MEMO

To	Development Management, Strategic Place Planning		
From	Jack Penman, Engineer, Roads Development Management		
E-mail	JPenman@aberdeencity.gov.uk	Date	21/08/23
		Our Ref.	DPP-230969
		Your Ref.

Planning Application No. DPP-230969

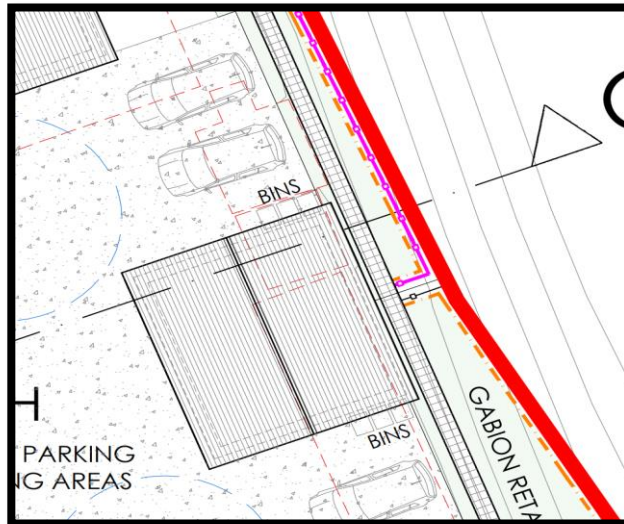
- 4.1. ACC parking guidelines for residential dwellings (4 or more bedrooms) is 3 allocated spaces.
- 4.2. I note the applicant has stated that there will be 14 parking spaces on the site. Which is 2 more than our guidelines.

- 4.3. It should be noted that all garages will only be counted as one parking space, provided that they meet the above minimum sizes.
- 4.4. I would note there only appears to be 12 dedicated spaces on the site then, which is in line with our guidelines. I would also note there appears to be adequate room to accommodate more parking for guests etc.

- 4.5. As the parking for the for some plots appears to be on the carriageway, effectively parking bays, the applicant should confirm that they meet ACC standards. Parking bays should generally be 2.5m x 5m with a 6m aisle width between bays. It does appear the space exceeds this, but confirmation is required.

- 4.6. For the spaces enclosed in the site (plots 3 and 4) these would be classed as a driveway. Driveways in new houses must have a minimum length of 6m. Double driveways must be at least 5m in width. The gradient of a driveway should generally not exceed 1:20.

- 4.7. The minimum acceptable external size of a new single garage is 6.0m x 3.0m, with a minimum internal size no less than 5.7m x 2.7m. The minimum effective entry width is 2.25m with a height of 1.98m. The acceptable size of a double garage is 6m x 6m external, with a minimum internal size no less than 5.7m x 5.7m (this is a local variation). For plots 1 and 2 they are to have a shared garage. The dimensions are acceptable. For plots 3 and 4 the dimensions for the double garages slightly exceed the above standards which is not a concern to Roads.

- 4.8. Access to the shared garage appears to be impeded by the bin storage location. Can the applicant comment on this?
